TREE ASSESSMENT

TEMANBIT COMMUNITY CENTRE

**SINCLAIRE and TYRELL STREETDS
TENAMBIT**

MAITLAND CITY COUNCIL

The assessment is based on the excerpt of the plans provided by Alison Cronin | Senior Project Architect | Maitland City Council below.

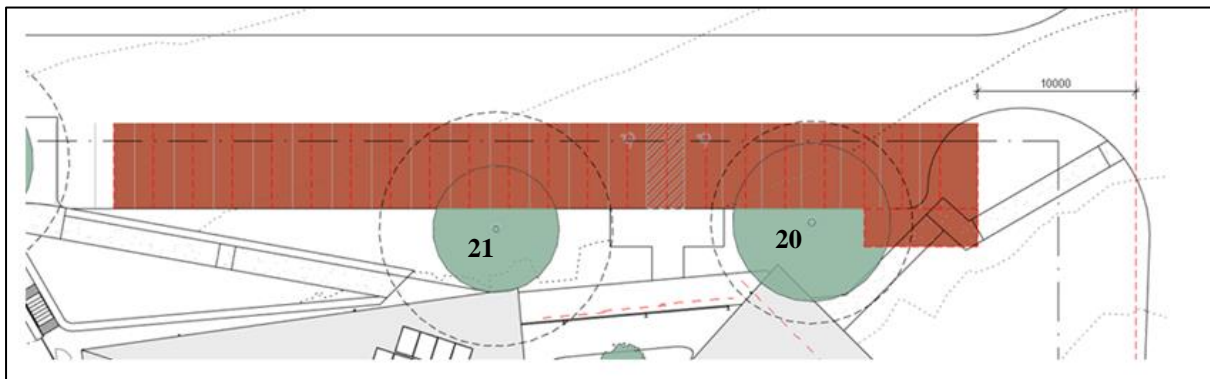
Based on the information provided changes to the carpark are required to elevate the southern alignment in the order of 200-250mm to achieve flatter grades over the carparking area that will result in changed levels at the base of the trees and construction within the TPZ & SRZ.

Whilst ground level is to be raised it is only expected to be minimal (200-250mm) and whilst soil fill can have a negative impact most trees can tolerate some fill up to about 300mm about their base if the roots have not been injured first.

Due to their close proximity to the existing bitumen construction will encroach well into the TPZ & SRZ off the trees. According to Australian Standards – AS 4970 – 2009, Protection of Tree on Development Sites encroachment is considered to be major where construction will encroach into the SRZ or encroach more than 10% into the calculated TPZ of a tree.

However, if existing bitumen and kerb & guttering is to be removed and replaced the main area of concern is damage to roots within the SRZ and excessive damage to roots within the TPZ particularly during the demolition and preparation process of the proposed works

Due to the close proximity of construction works in relation to the extent of encroachment into their TPZ /SRZ's it is considered that should the works proceed as proposed without regard to roots that the trees are likely to be adversely impacted upon in a manner that could be detrimental to both stability and health & vigour.

Ideally, if possible, the existing bitumen should be retained and new sub-base and bitumen laid directly on top. This will eliminate the need for any excavation works and potential for damage to roots and impacts associated with compaction, oxygen supply and associated beneficial fungi and micro-organisms is not likely to be significantly altered.

This can be achieved by the careful removal of existing bitumen and kerb & guttering and must be undertaken with extreme care and in a manner that will avoid damage to roots.

However, if roots are encountered within the SRZ and / or numerous roots within the TPZ are encountered works should cease and the project arborist should be consulted. Based on further assessment it can then be determined whether retention and design can be achieved or alternative solutions are required.
